ADDENDUM NO. 2

UTILITY INFRASTRUCTURE IMPROVEMENTS
WAPPAPELLO TRAINING SITE
WAPPAPELLO, MISSOURI
PROJECT NO.: T2213-01

August 18, 2022

APPENDIX C

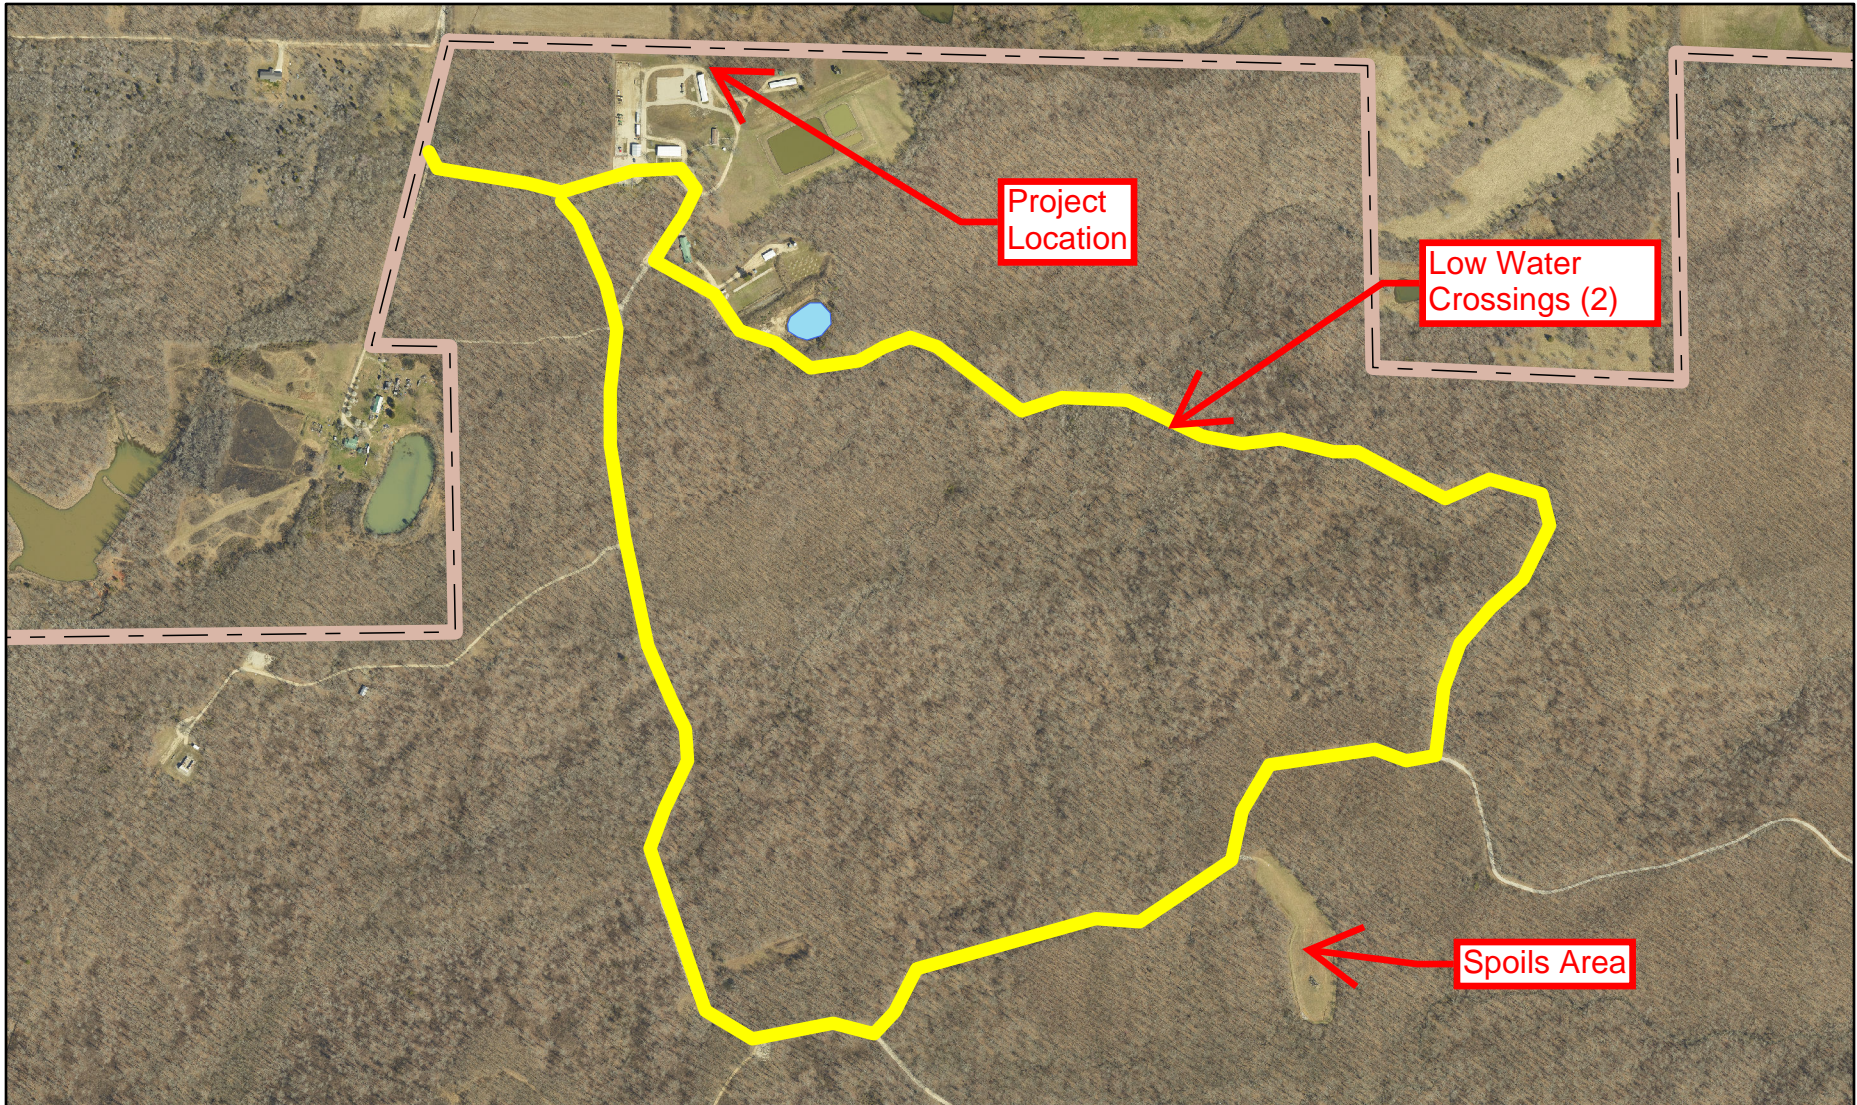
- A. Removal from Project Site: Remove excess soils, including unacceptable excavated material, from site to an approved location ~~on the coordinate with owner.~~ *or the spoil material may be placed within the Owner's designated spoil material site shown at the end of this specification. Spoil placed on the Owner's spoil material site shall be evenly graded and seeded per Section 329219 Seeding.*

ADD Appendix C, Excess Spoil Material Disposal Location

C-101

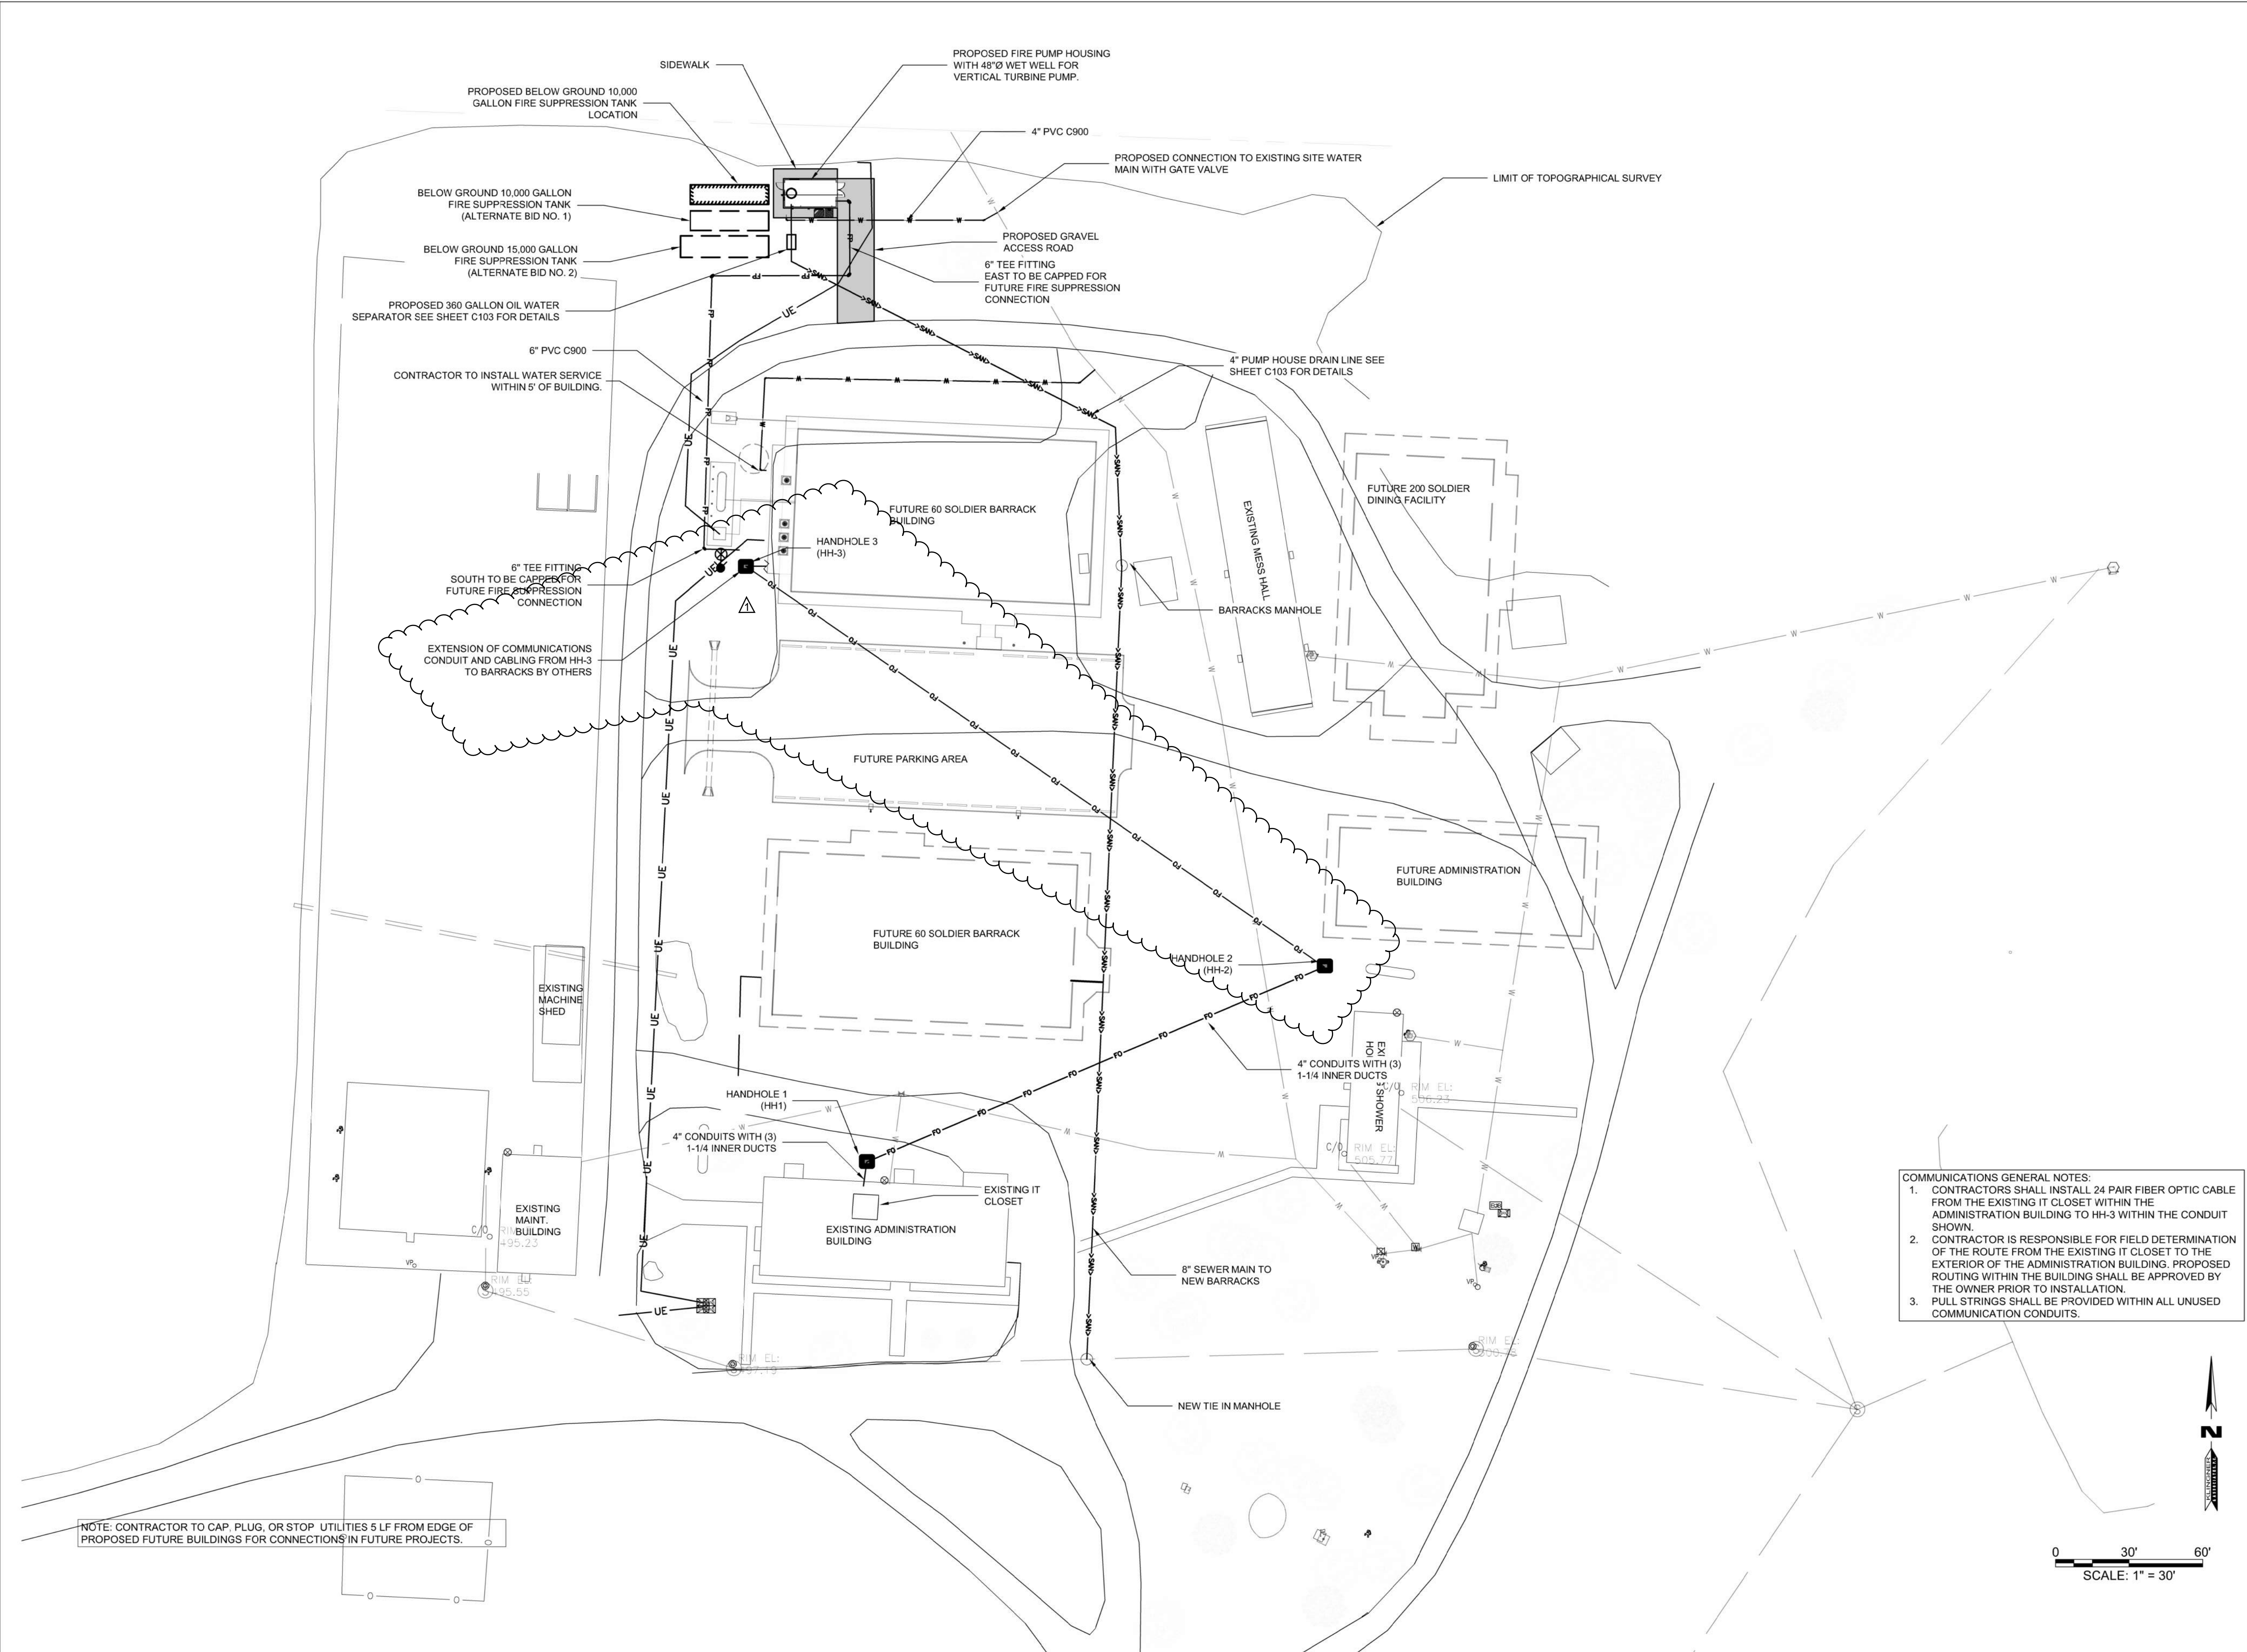
1. Sheet C101

MODIFY Handhole HH-3 has been relocated to the west side of the proposed barracks building.
